PCM Service Bulletin

Dampener Plate Noise

#SUP2007-01

**Engines Affected: Engine Serial Number Range 462197 through 470936
V-Drive Models ONLY - xx-570V-xx and xx-600V-xx**

Suspect Dampener Plate - Note the dampener springs are covered.

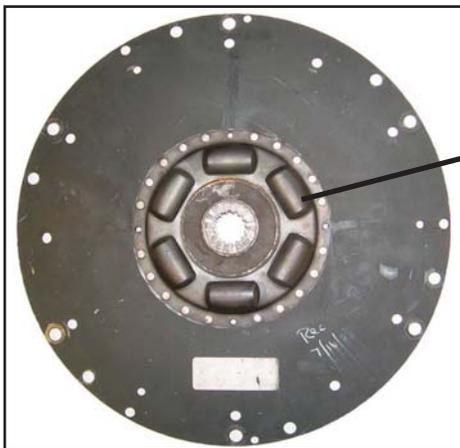
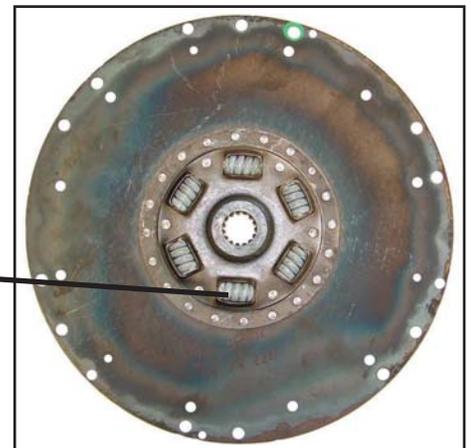
The dampener plate, in some cases, creates a 'rattle'. The 'rattle' occurs in forward gear, at idle speed, after a prolonged (1-2 minutes) idle. Upon investigation, PCM has found the source of the problem to be a spring tension issue with *some* of the dampener plates used on the engines in the affected serial number range. **Be assured that this is a noise issue only, absolutely no adverse wear or damage is occurring in the drive train or engine.**

Please inspect your inventory and replace stock Dampener Plates, P/N R140016, that look like the picture below left. Submit a FASTFAX form with 'PARTS' on the serial number line, to exchange for the current Dampener Plate. (Refer to the picture below right, for the current Dampener Plate, P/N R140016.)

Current Dampener Plate - Note the dampener springs are uncovered.

In order to maintain the highest level of customer satisfaction, PCM recommends that dealers check all V-drive boats, in the affected serial number range, for the 'rattle' as part of the Pre-Delivery Inspection or recommissioning after winter storage. This check can be accomplished by idling the boat in forward gear for 1 to 2 minutes. PCM will authorize the replacement of the Dampener Plate (R140016) on boats that have the condition present.

In order to receive replacement Dampener Plate(s), complete a PCM Warranty FASTFAX application referencing this service update (#SUP2007-01) and fax it to the PCM Warranty Department. Replacement Dampener Plate(s) will be shipped once the claim is received.
